600 E Pike

Design Review Board Recommendation Meeting

600 E Pike Street, Seattle, WA 98122

DPD #3014172

Setback Above Character Structures: Departure 2

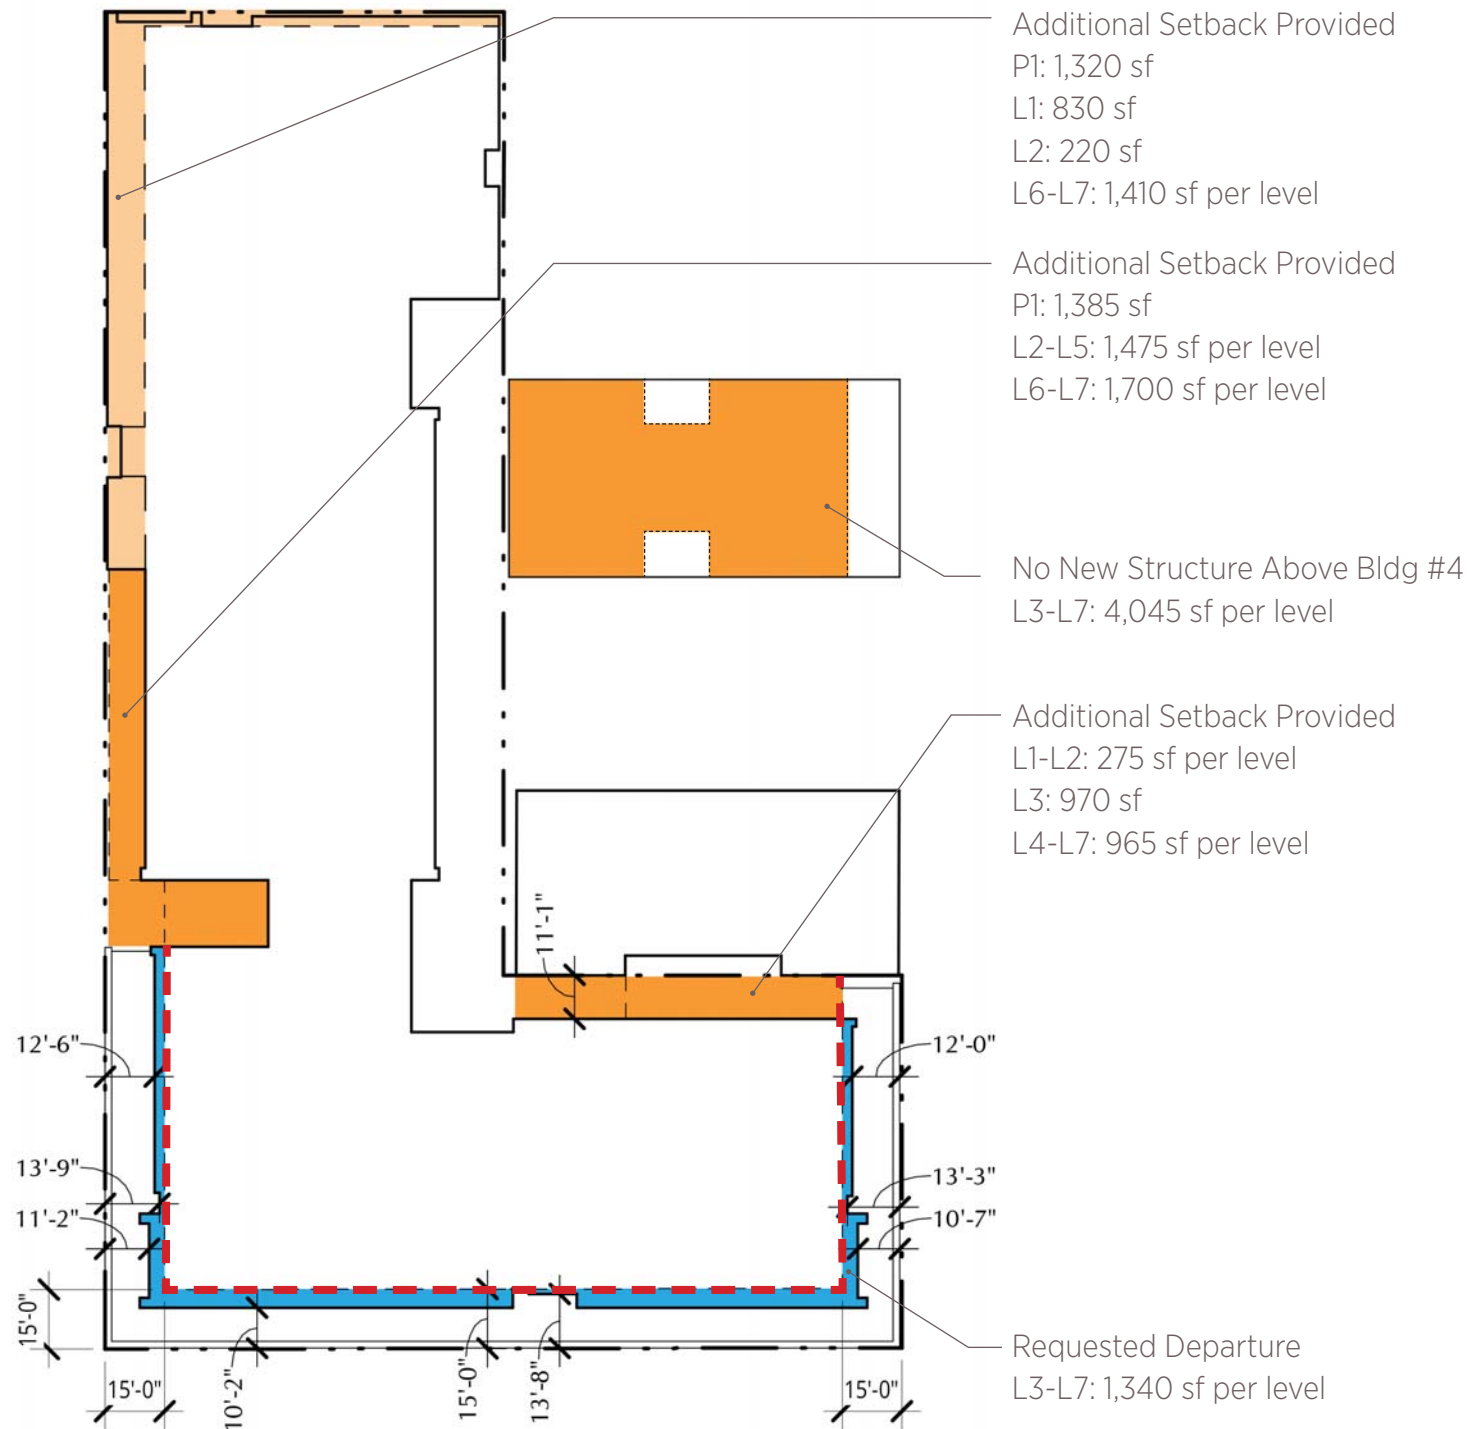
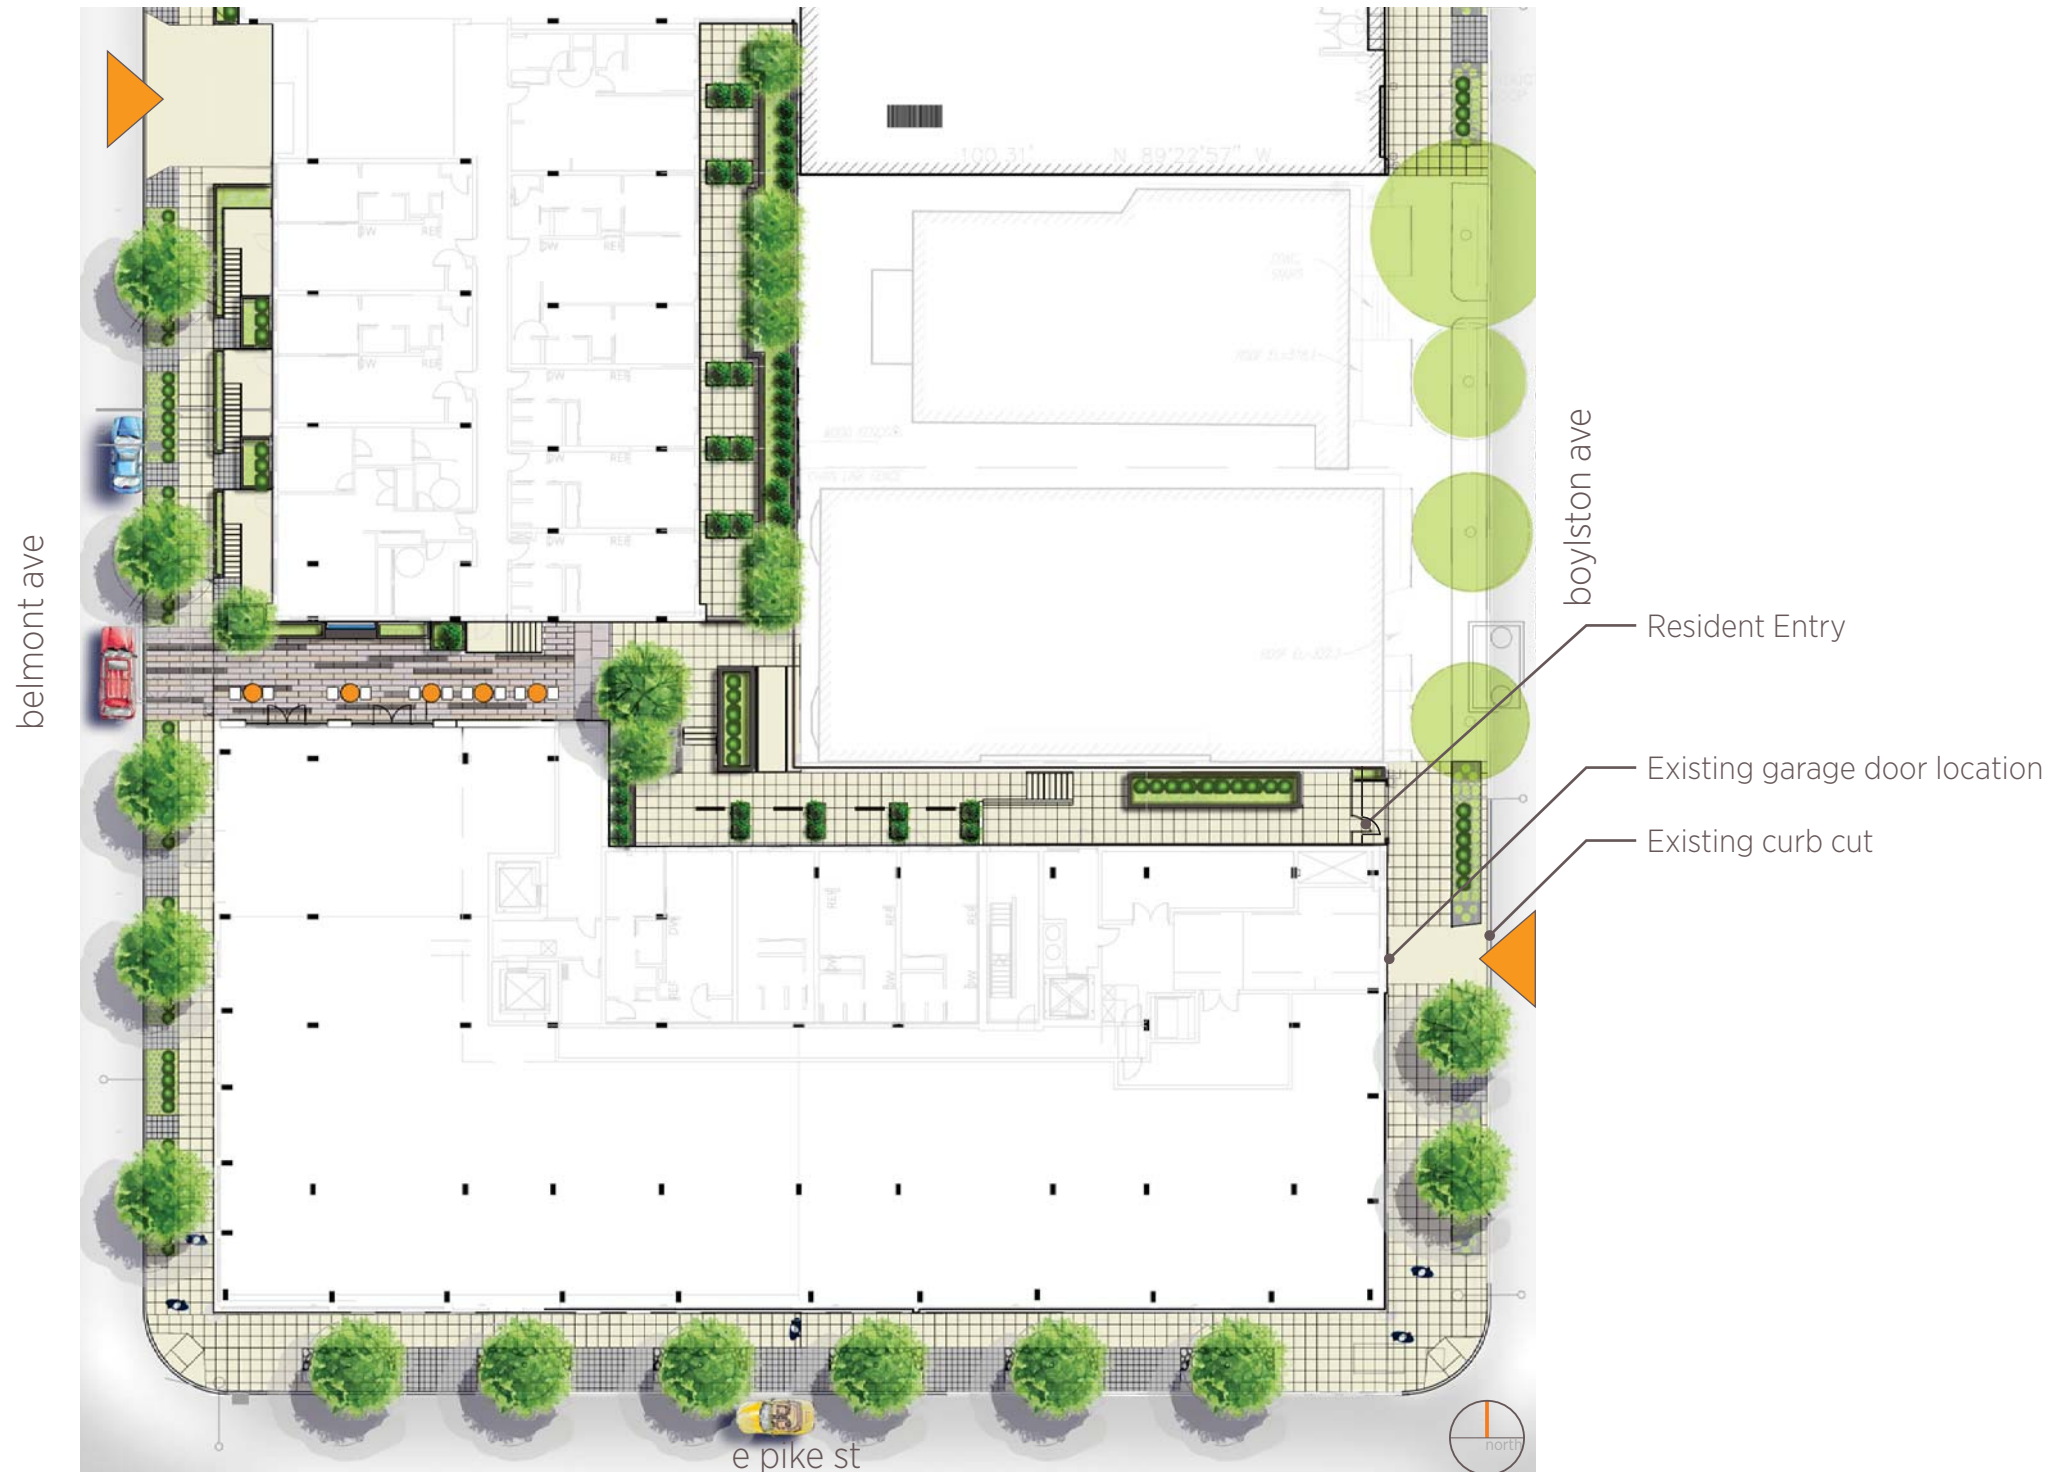
CODE
 23.73.010 All portions of the new structure above the height of the street-facing facades of the character structure are set back a minimum of 15 feet from all street property lines that abut the Character Structure

REQUEST
 The design team wishes to vary the setbacks above the character structures. Setbacks along Belmont Ave vary from 8'-6" to 12'-6". Setbacks along E Pike St vary from 10'-0" to 13'-6". Setbacks along Boylston Ave vary from 8'-6" to 12'-6". This is a major increase from the EDG setbacks of 5'-0" to 10'-0".

- An additional setback of 11'-0" is added between our project and the adjacent property to the north (Glencoe Apartments) as well as a ground level setback along Belmont Ave.
- The plaza between our buildings will be open to the public.
- An upper level setback is provided on both Belmont and E Pine St.
- Rather than develop over it, we have also chosen to retain the ENTIRE character structure of Building 4 with no building above.
- Design Guidelines A-5, A-6, A-7, B-1, B-2, C-3 D-12, E-2

Vehicle Access and Maneuvering: Departure 3

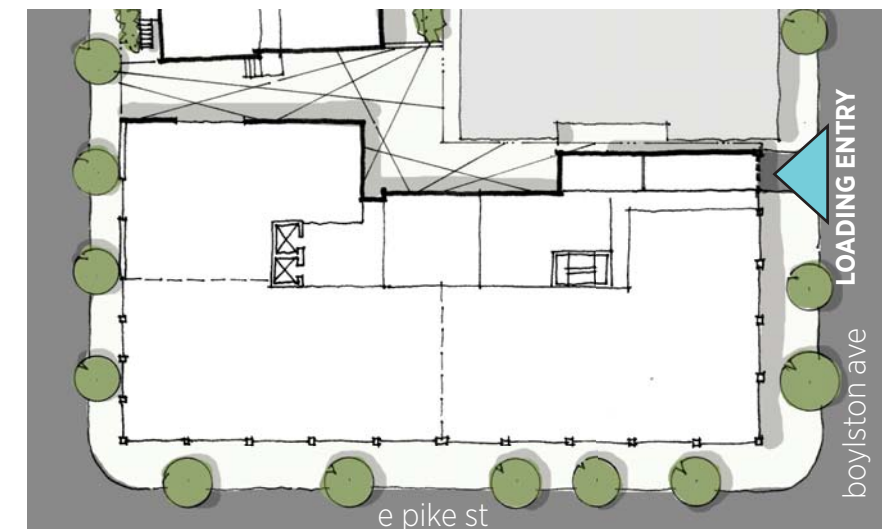
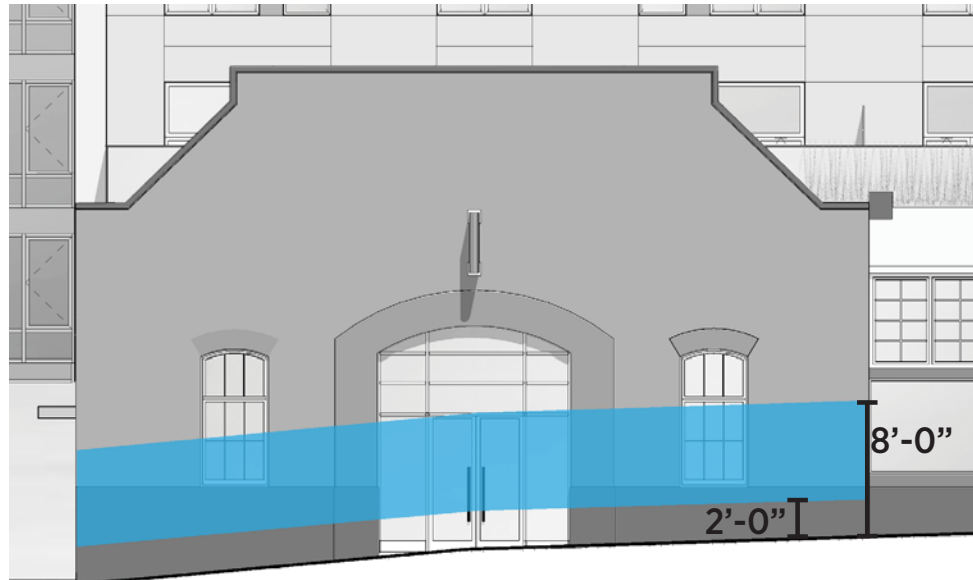
CODE
 23.47A.032.A.1.C. "If access is not provided from an alley and the lot abuts two or more streets, access is permitted across one of the side street lot lines pursuant to subsection 23.47A.032.C, and curb cuts are permitted pursuant to subsection 23.54.030.F.2.a.1."

REQUEST
 The main automobile entry would be located on Belmont Ave and an additional curb cut on Boylston Ave would serve the loading berth providing truck parking for both retail tenants and residents moving in.

- The building is pulled away from the Glencoe Apartments, creating a small courtyard and pedestrian entry off Boylston Avenue.
- The loading berth will be used frequently by both the future retail and the apartment renters; locating the berth internally will help keep pedestrians safe and shield the loading and trash uses from the neighborhood.
- Design Guidelines A-2, A-5, A-8, D-6, D-7

Street-Level Standards: Departures 4, 5

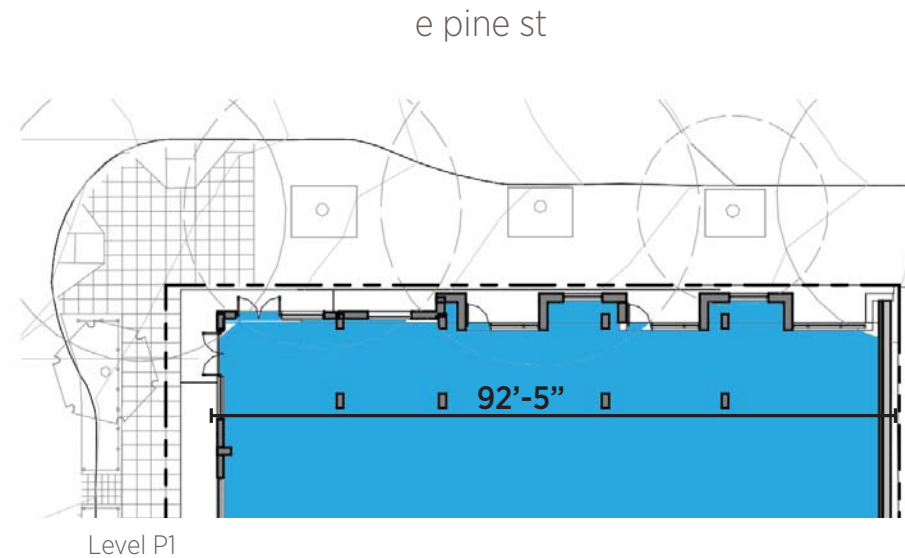
23.47A.008.B.2.A. "Sixty percent of the street-facing facade between 2 feet and 8 feet above the sidewalk shall be transparent."

The retained facade of the garage character structure (Building 1) does not meet the street-level transparency requirement. We request that the transparency requirement be waved at the character structure facade.

- The design team proposes to restore storefront to the existing openings in the character structure facade.
- Further modification to this facade will compromise the integrity of the character structure.
- Design Guidelines: B-7, C-1

Street-Level Standards: Departures 6, 7

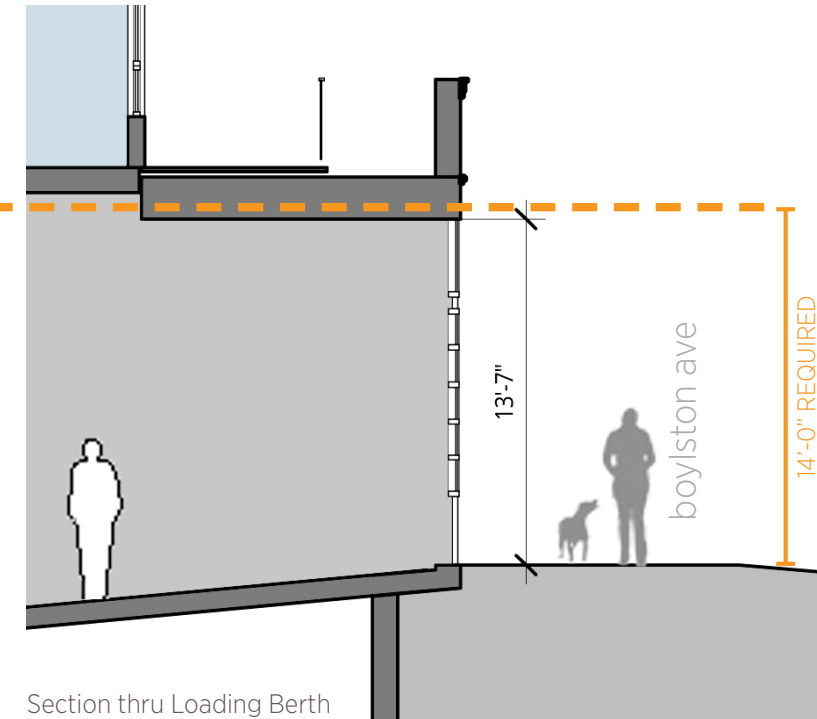
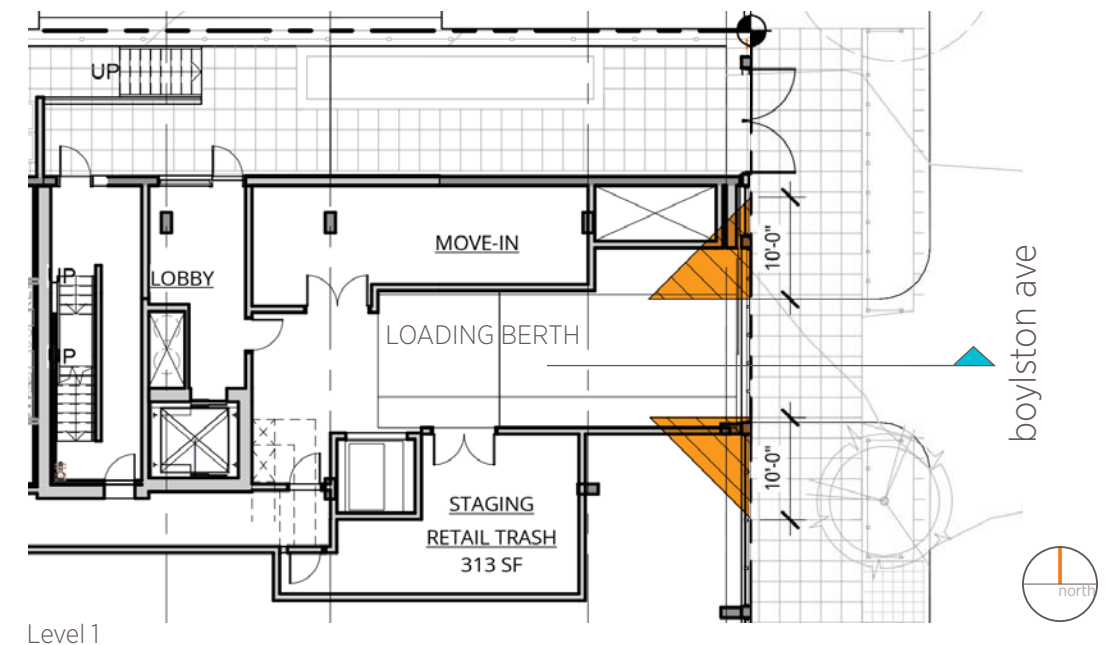
23.54.035.C.1-2. "Each loading berth shall not be less than 10' in width and shall provide not less than 14' vertical clearance and they shall be a minimum of 35' in length."

23.54.030.G.1. "For two way driveways less than 22', a sight triangle on both sides of the driveway shall be provided, and shall be kept clear of any obstruction for a distance of 10 feet from the intersection."

The vertical clearance and sight triangle requirements are not met at the loading berth on Boylston Avenue.

- The location of the current curb cut and garage door on Boylston Avenue will be reused for the loading berth. The height of the existing opening is 0'-5" short of the required vertical clearance.
- The retained facade of the character structure does not allow for the required sight triangles.
- Altering the facade of Building 3 will compromise the integrity of its character.
- Design Guidelines A-2, A-4, A-5, B-2, B-3, B-7, D-7

Street-Level Standards: Departures 4, 8

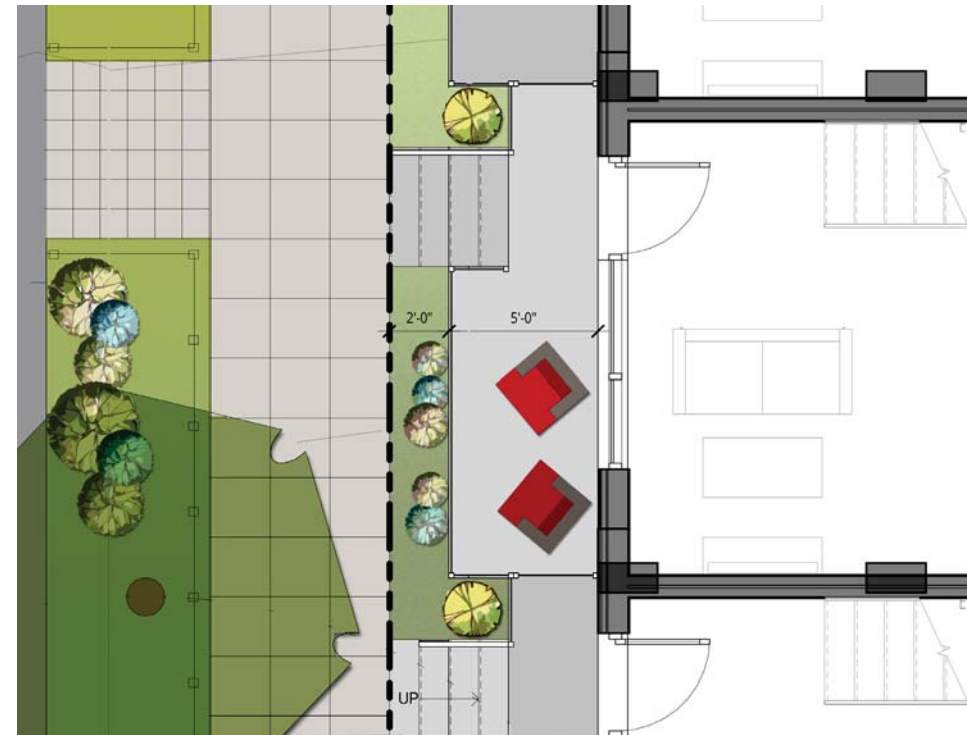
23.47A.008.D "The floor of a dwelling unit located along the street-level street-facing facade shall be at least 4 feet above or below sidewalk grade or be set back at least 10 feet from the sidewalk."

The design team requests less than the code-required setback. The proposed solution incorporates both a setback of 7'-0" and a vertical separation which varies from 1'-0" to 3'-0".

- The combination of a horizontal setback and a change in elevation from street level work together to distinguish private residences from the public realm.
- Strips of landscaping and frosted guardrails define the edge between the public sidewalk and private decks.
- The setback allows plenty of room for a comfortable outdoor space with these three street-facing loft units.
- Design Guidelines A-6, C-3, D-7, D-12
